N9935A-02

S E R V I C E N O T E

N9935A FieldFox Handheld Analyzer

Figure 1: Image showing the good and bad inductor on location U678 at RF Board

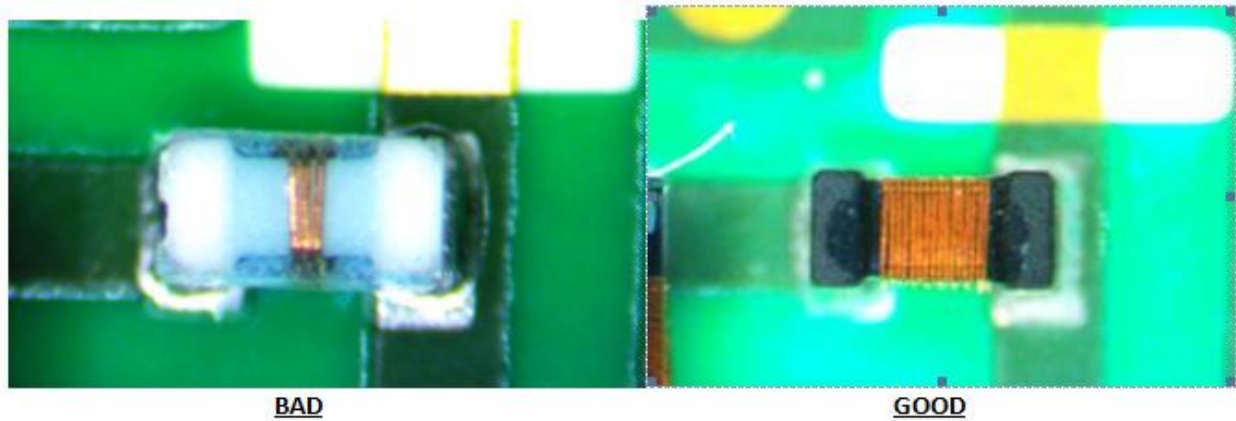
FieldFox instruments with the serial numbers listed below may show potential DANL failures with 3-4 dB difference due to misloaded inductor on the RF board. If DANL improvement is necessary, a new RF board is available to fix this it.

Affected FieldFox with necessary DANL improvement are required to send back to Agilent factory for a new RF board replacement. Test and Adjustment shall be done before shipping back to customer.
